Product Change Notice (PCN)

PCN Number: **PCN-0450983R-01**

Product(s) Affected: *SJ1-353XNS Series (SJ1-3533NS, SJ1-3534NS & SJ1-3535NS)*

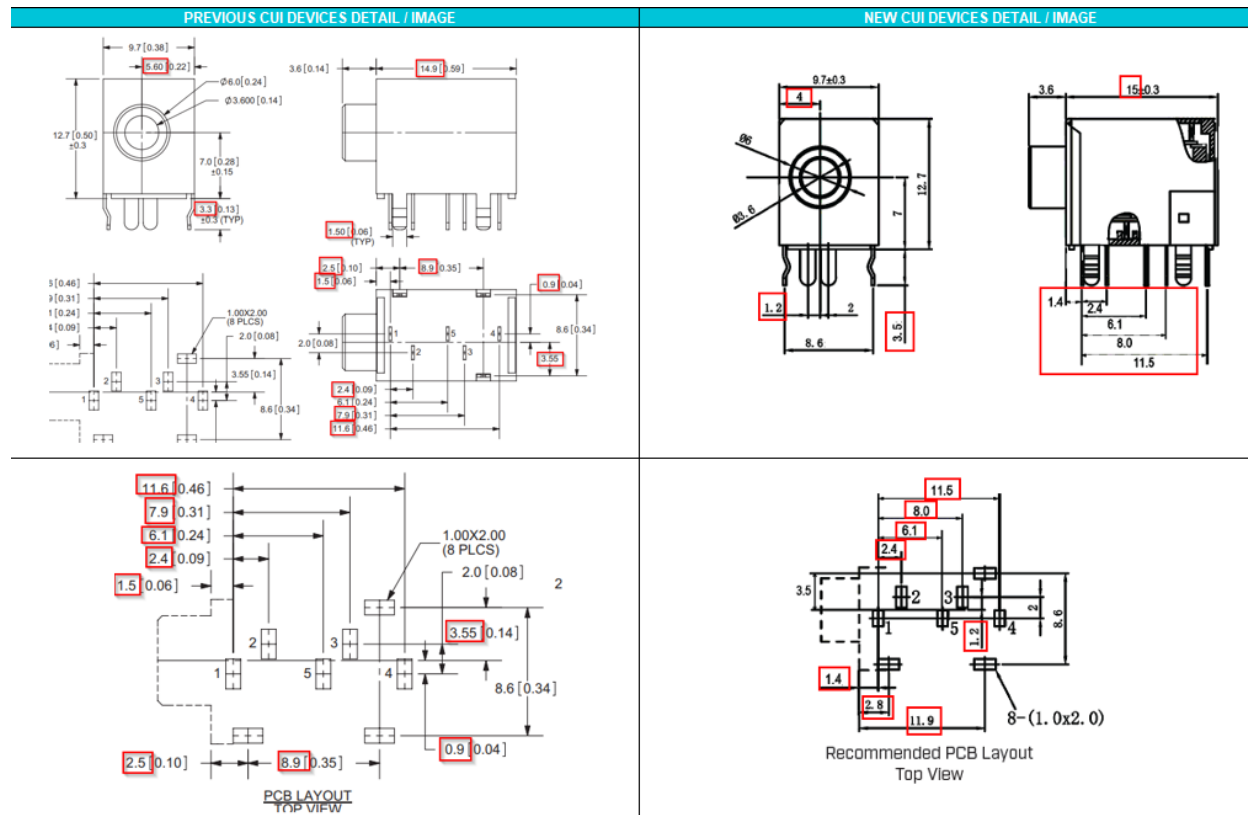
Description of Change: *Minor Housing and footprint differences. Material Change on the housing and terminals. See image Below*

PREVIOUS CUI DEVICES DETAIL / IMAGE			NEW CUI DEVICES DETAIL / IMAGE		
	MATERIAL	PLATING	DESCRIPTION	MATERIAL	PLATING/COLOR
terminal 1	brass	tin	terminal 1	brass	silver
terminal 2	brass	tin	terminal 2	phosphor bronze	silver
terminal 3	brass	tin	terminal 3	phosphor bronze	silver
terminal 4	brass	tin	terminal 4	brass	silver
terminal 5	brass	tin	terminal 5	brass	silver
spring	stainless steel		spring	stainless steel	nickel
bushing	brass	nickel	bushing	brass H59	nickel
shield	cold rolled steel	nickel	shield	SPCC t=0.30	nickel
plastic	PBT		housing	PBT (UL94V-0)	black
